State of Hawaii
DEPARTMENT OF LAND AND NATURAL RESOURCES
ENGINEERING DIVISION
1151 Punchbowl Street, Room 221
Honolulu, Hawaii 96813

ADDENDUM NO. 2

Job No. F48C612A
Keaiwa Heiau State Recreation Area Water System Improvements
Aiea, Hawaii

May 19, 2026

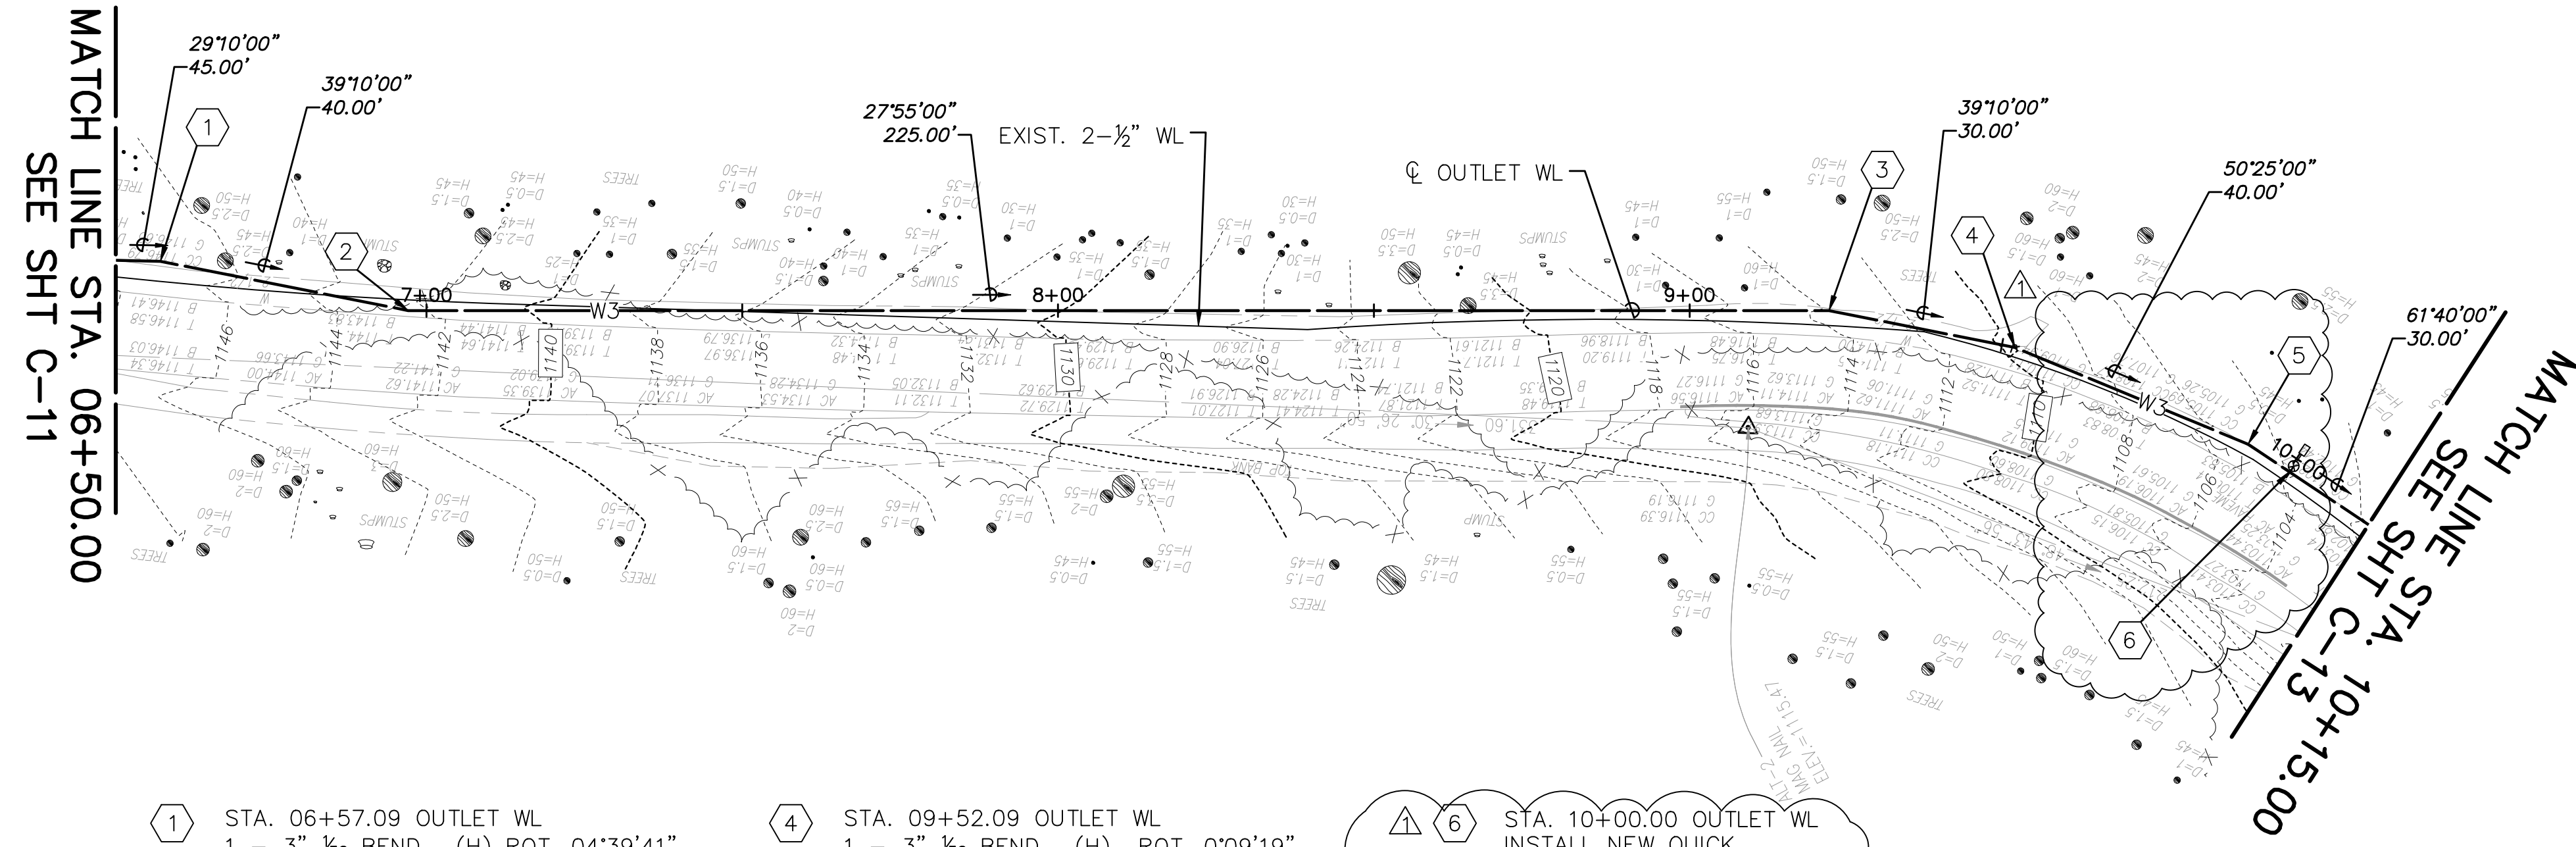
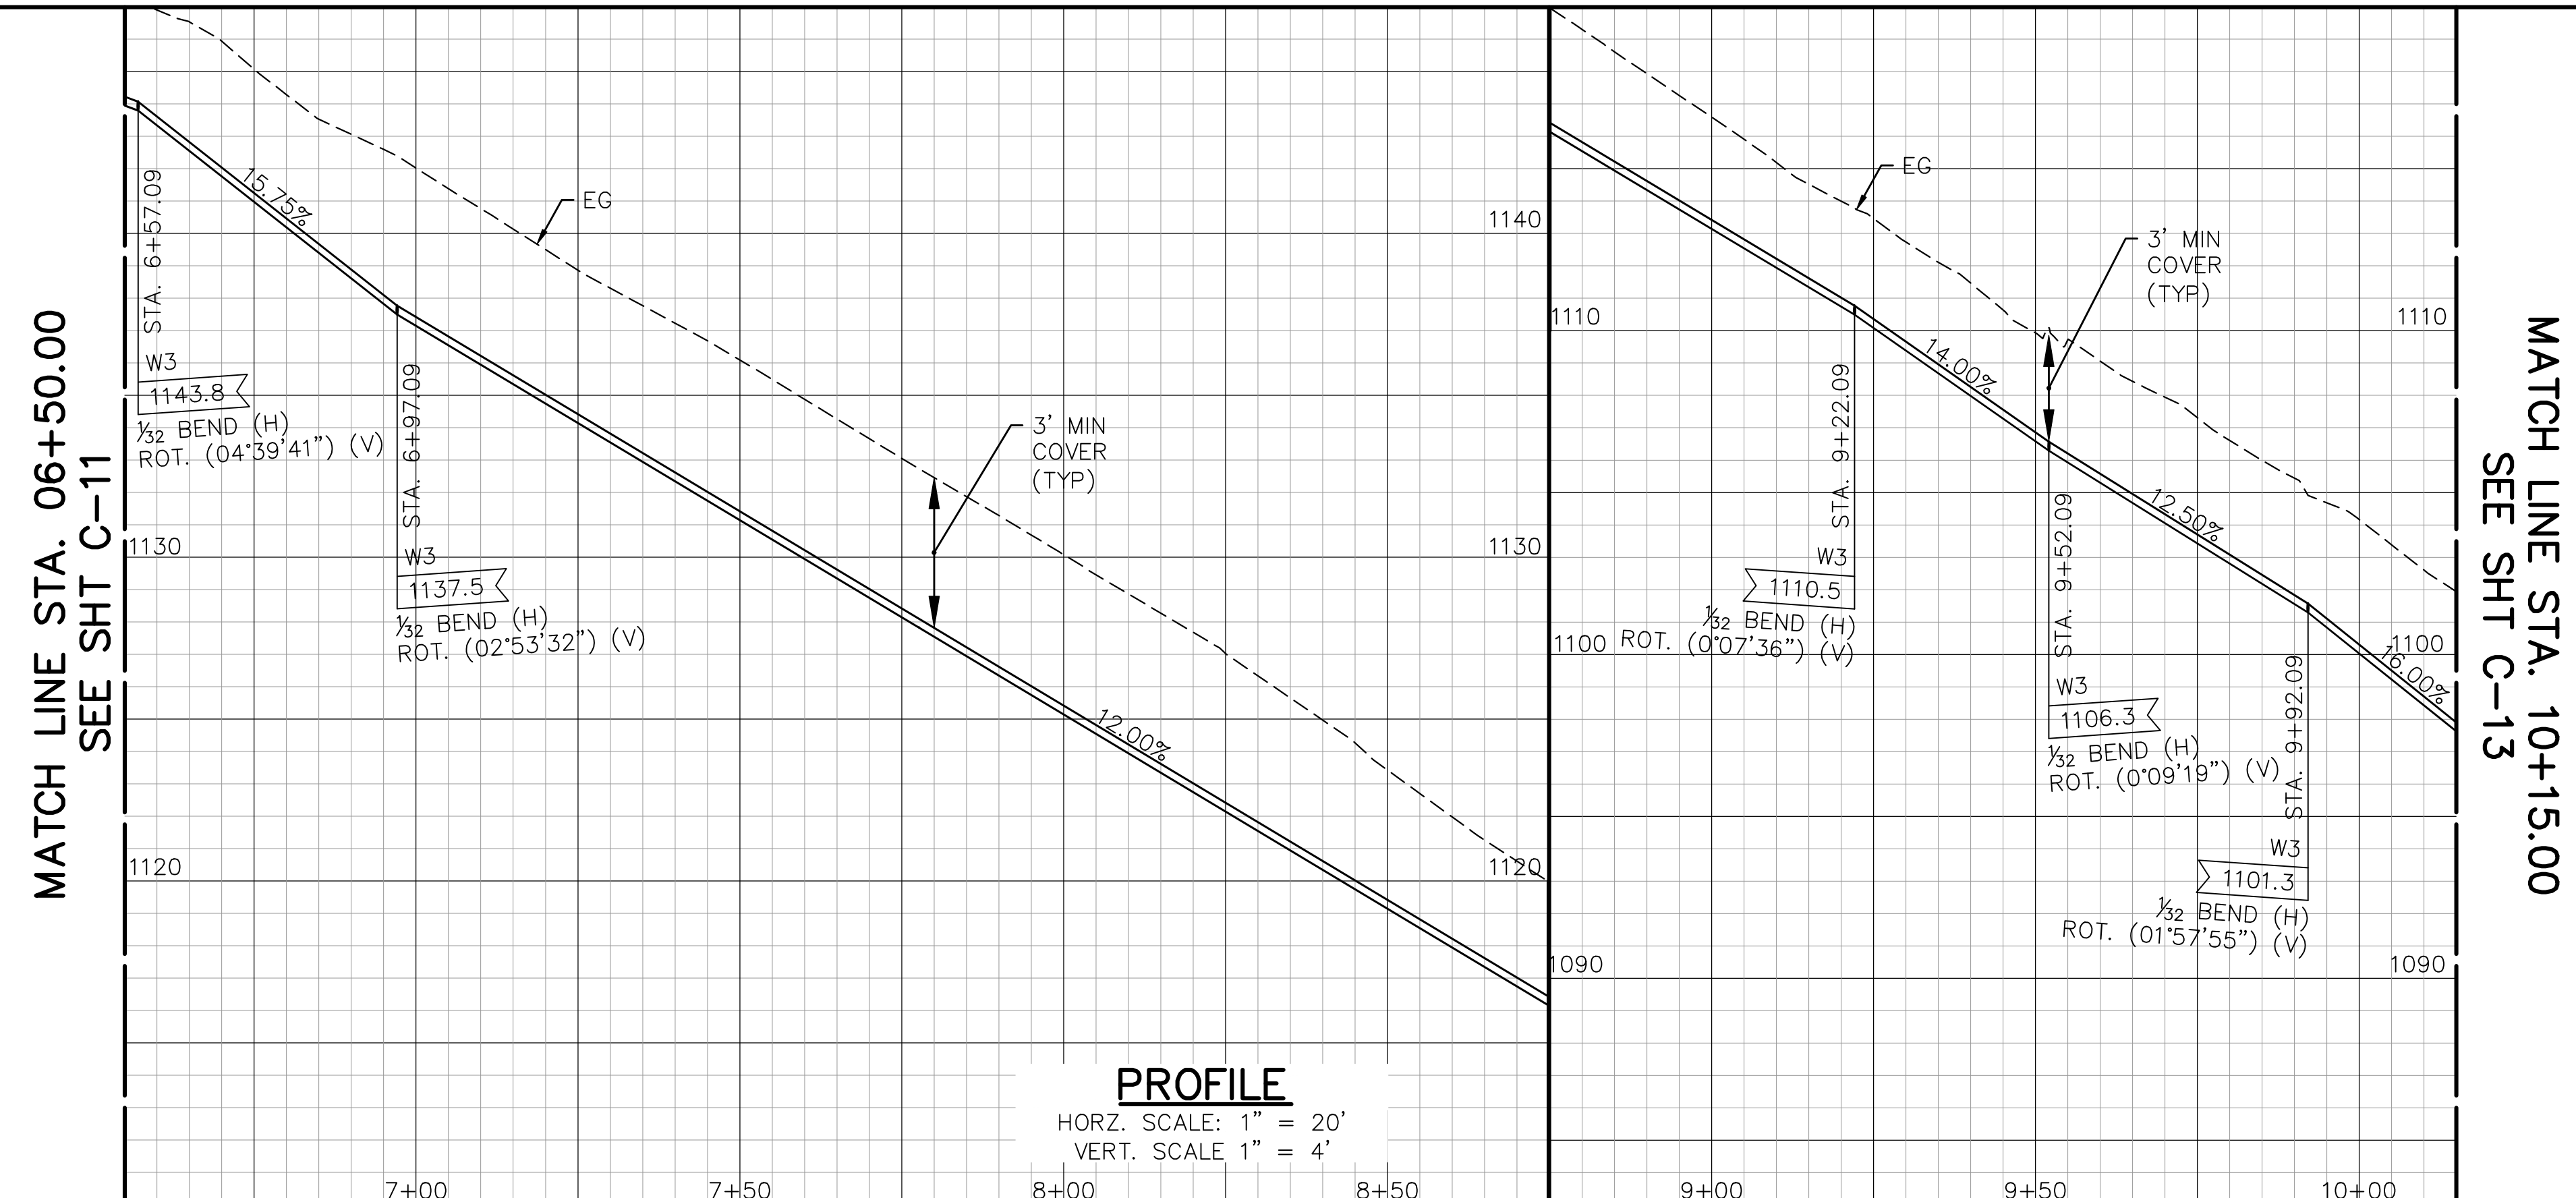
7. Sheet C-12 – Plan & Profile 7, Replace sheet with the attached revised Sheet C-12.

- ① STA. 06+57.09 OUTLET WL
1 - 3" 1/2 BEND, (H) ROT. 04°39'41"
1 - CONC. BLOCK
- ② STA. 06+97.09 OUTLET WL
1 - 3" 1/2 BEND, (H) ROT. 02°53'32"
1 - CONC. BLOCK
- ③ STA. 09+22.09 OUTLET WL
1 - 3" 1/2 BEND, (H) ROT. 01°07'36"
1 - CONC. BLOCK
- ④ STA. 09+52.09 OUTLET WL
1 - 3" 1/2 BEND, (H) ROT. 0°09'19"
1 - CONC. BLOCK
- ⑤ STA. 09+92.09 OUTLET WL
1 - 3" 1/6 BEND, (H) ROT. 01°57'55"
1 - CONC. BLOCK
- ⑥ STA. 10+00.00 OUTLET WL
INSTALL NEW QUICK
COUPLING VALVE W/ BALL
VALVE. SEE DET.
